**Sandia National Laboratories
Albuquerque, New Mexico
December 19, 2003**

**Environmental Restoration Project
Responses to New Mexico Environment Department
NOTICE OF DEFICIENCY**

**for the
Mixed Waste Landfill: Corrective Measures Study Report, May 2003
EPA ID#: 5890110518
HWB-SNL-01-025**

Figure 1-3
Map of the Mixed Waste Landfill

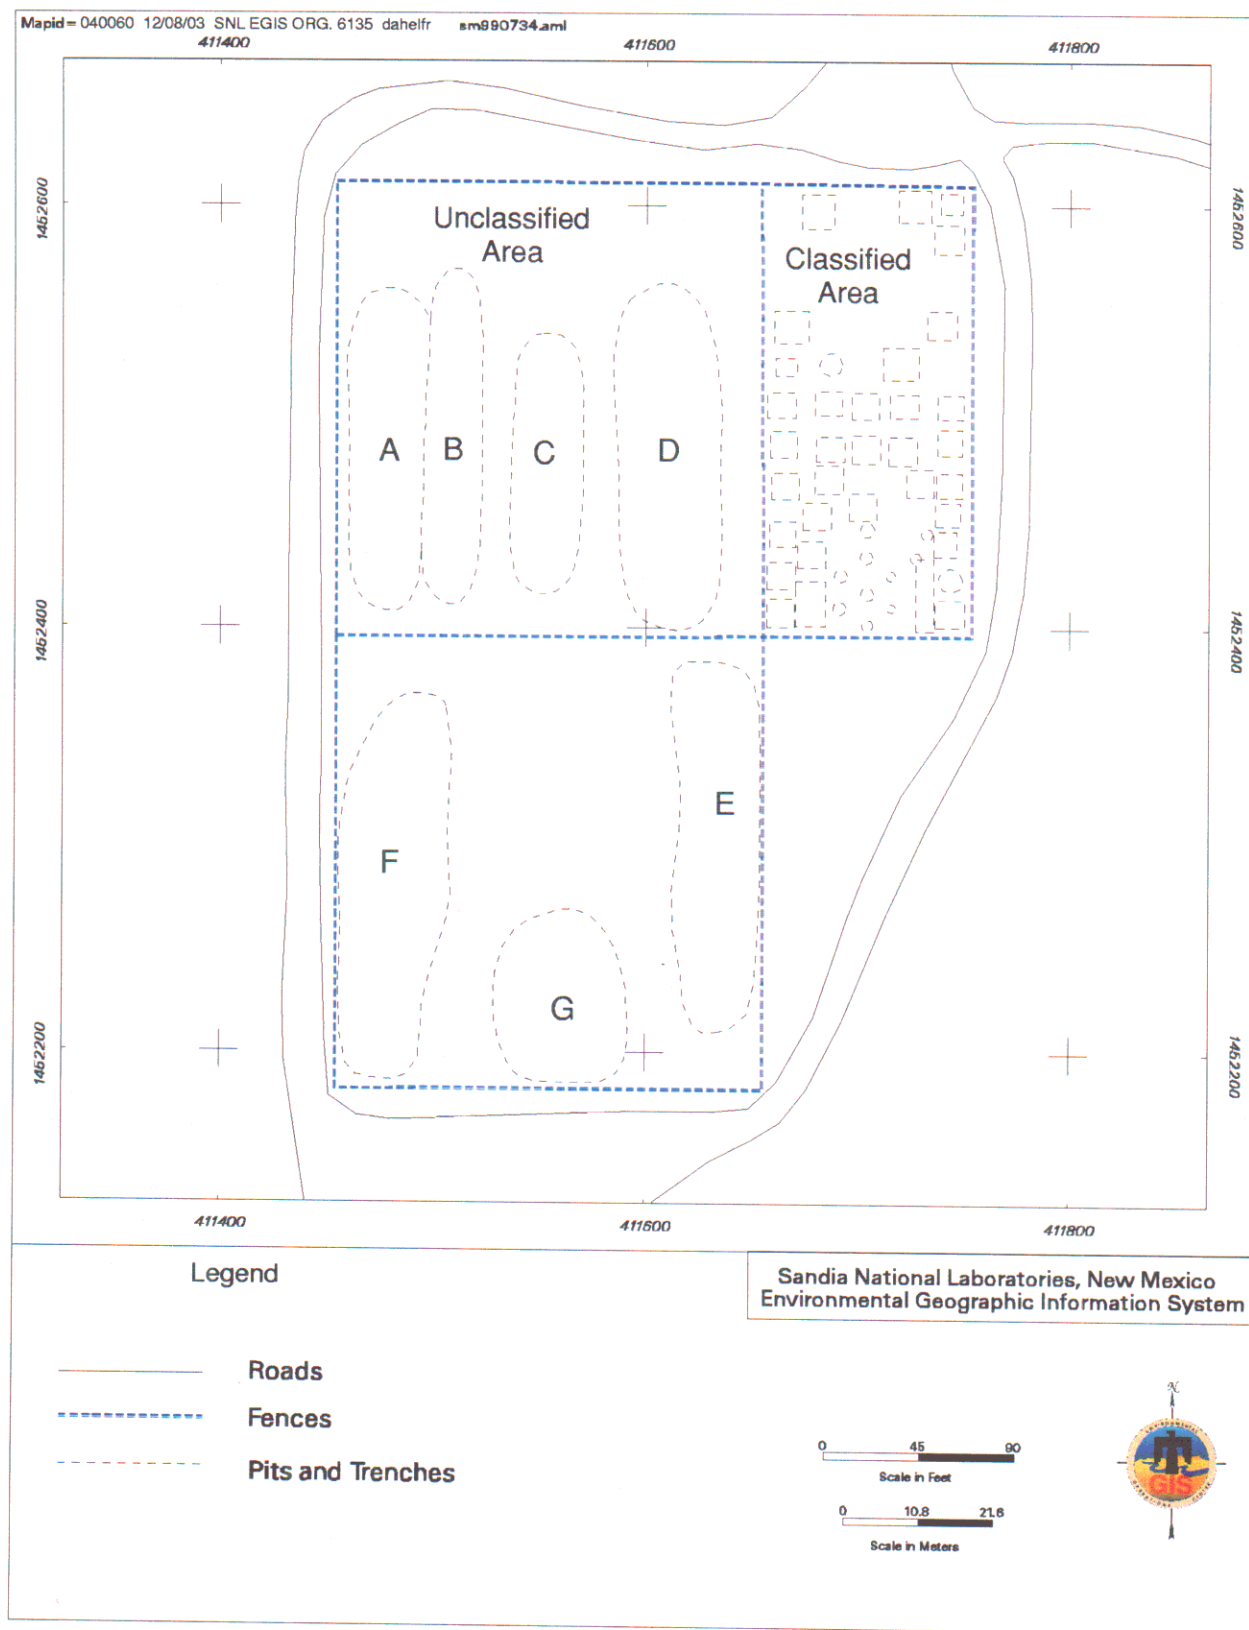
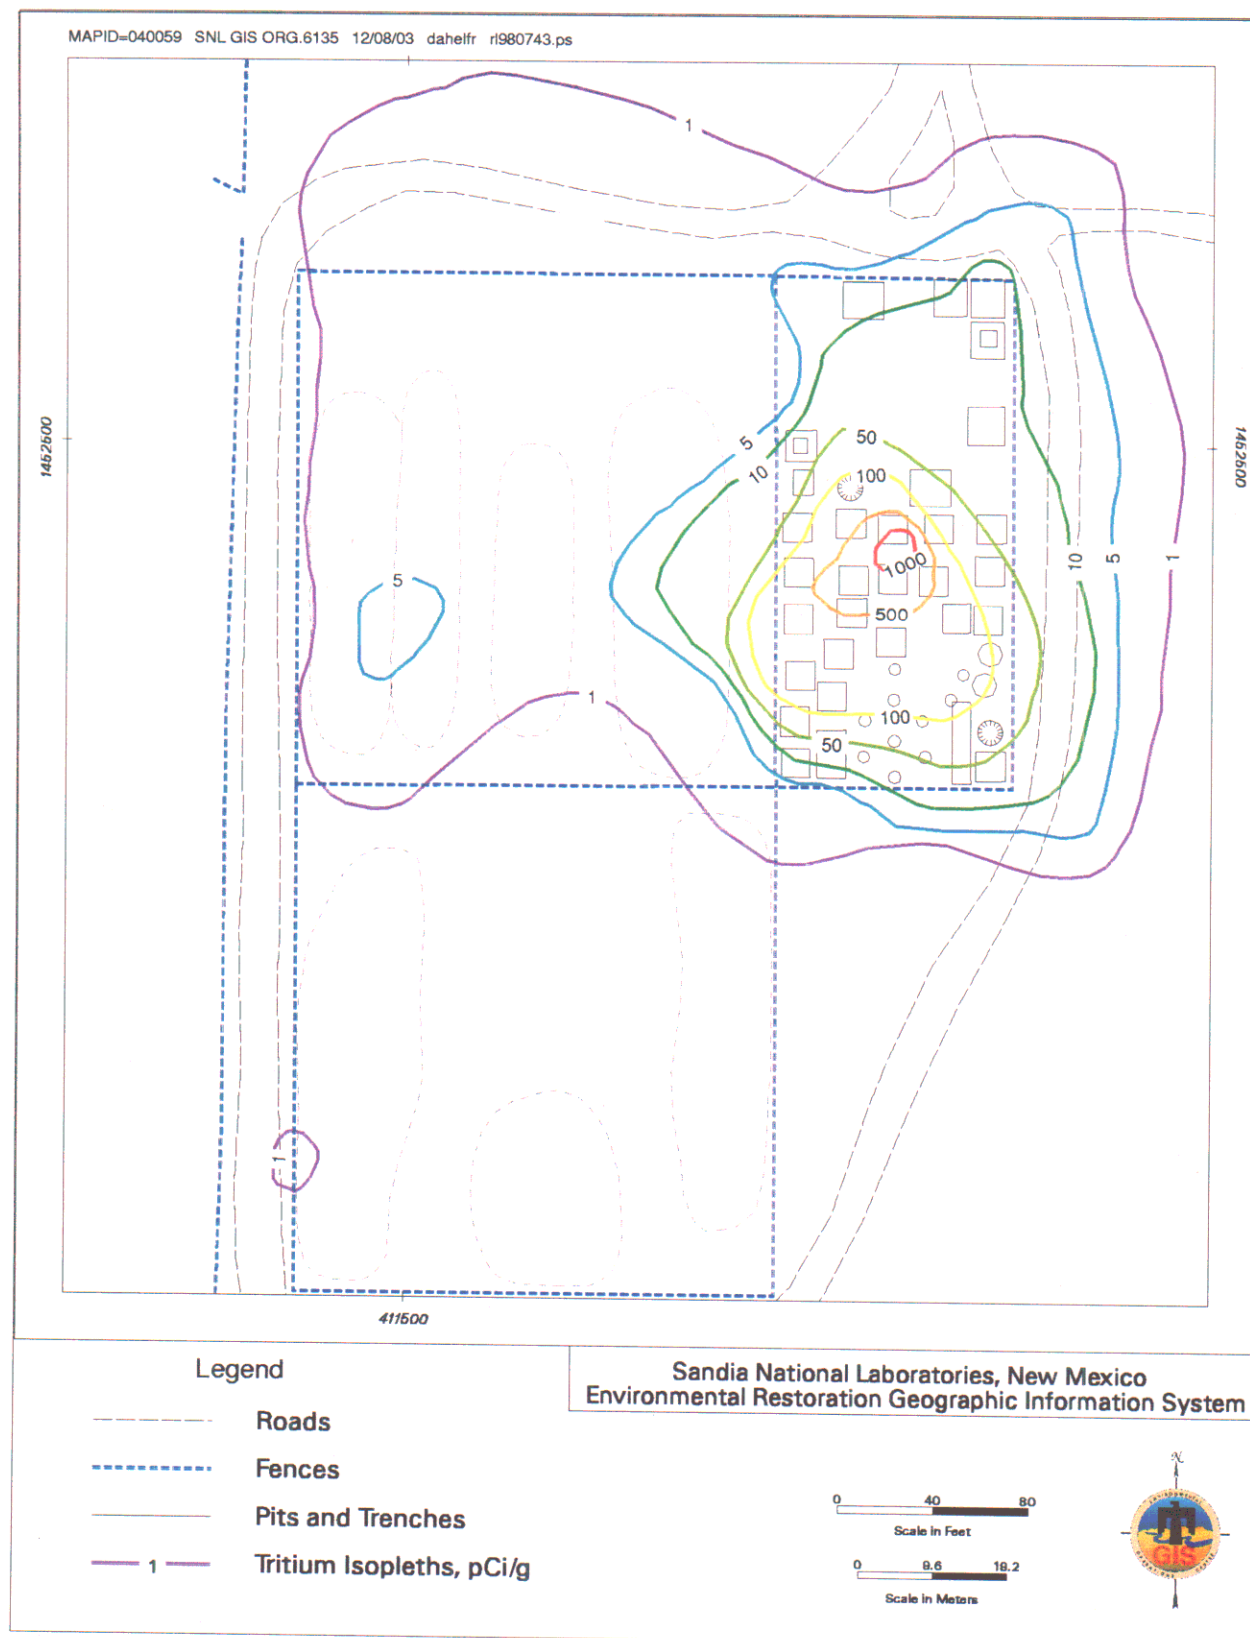
10. Figures 1-3 and 1-4. There is a dashed line in both figures separating the northern and southern halves of the unclassified area. In Figure 1-3, the dashed line presumably represents part of the MWL perimeter according to the legend. In Figure 1-4, it represents a fence. Provide clarification.

DOE/SNL Response: The dashed lines in Figures 1-3 and 1-4 represent MWL fencing. The outermost dashed line represents perimeter fencing. The legend in Figure 1-3 has been revised for clarification. The revised Figure 1-3 and Figure 1-4 are included in Attachment A.

Figure 3-1 Completed Excavation with Aboveground Retrievable Storage

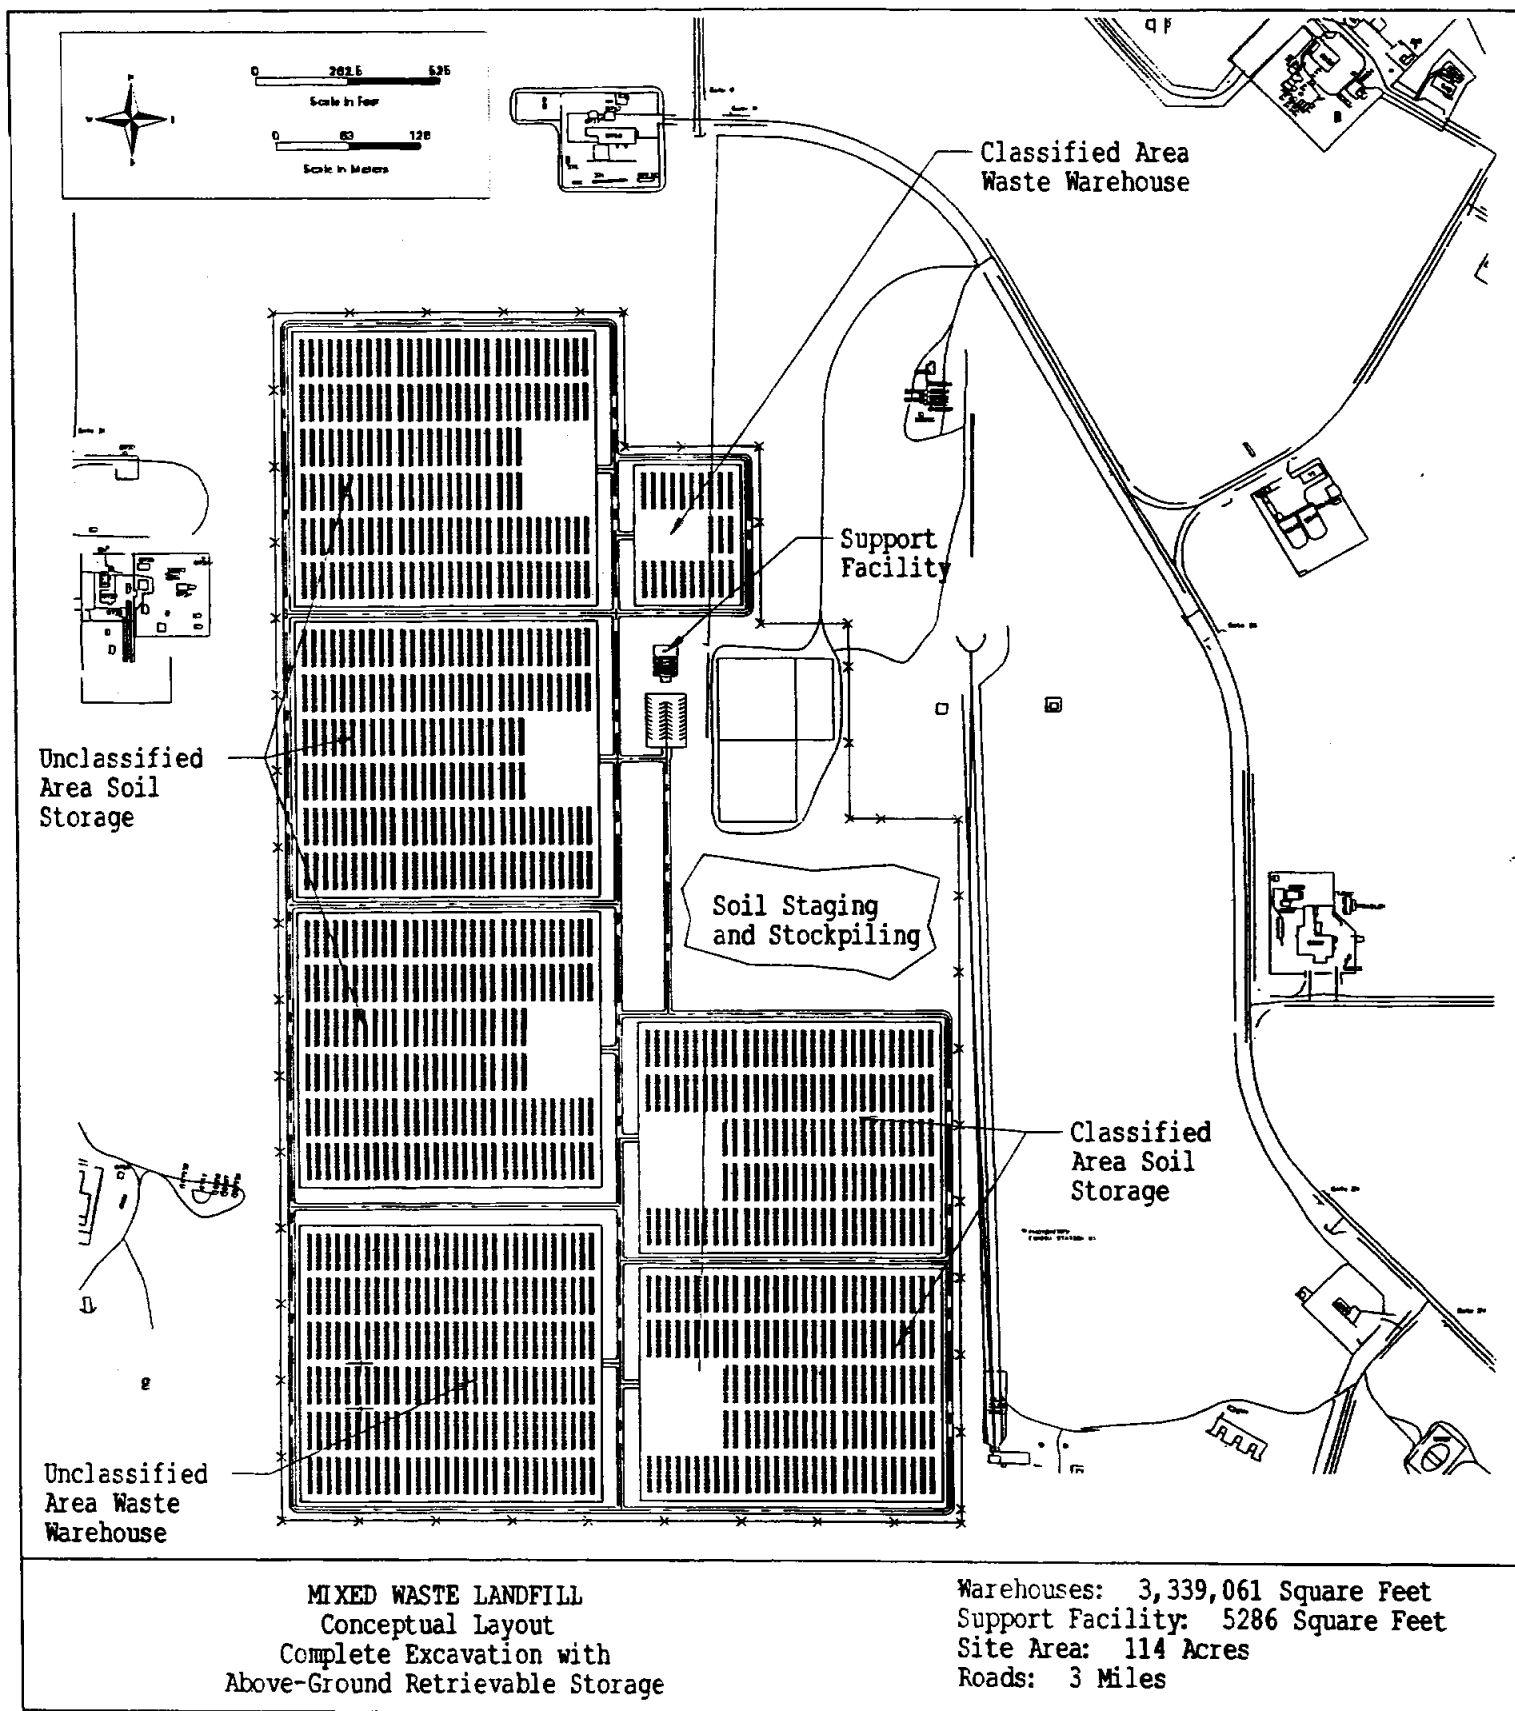
11. Figures 3-1 through 3-7. All of these figures do not include a scale. Resubmit the figures with the appropriate scales included. The addition of an arrow to indicate the north direction on each figure should also be included for the benefit of the public.

DOE/SNL Response: An appropriate scale and a north arrow will be added to Figures 3-1 through 3-7. The revised figures are included in Attachment A.
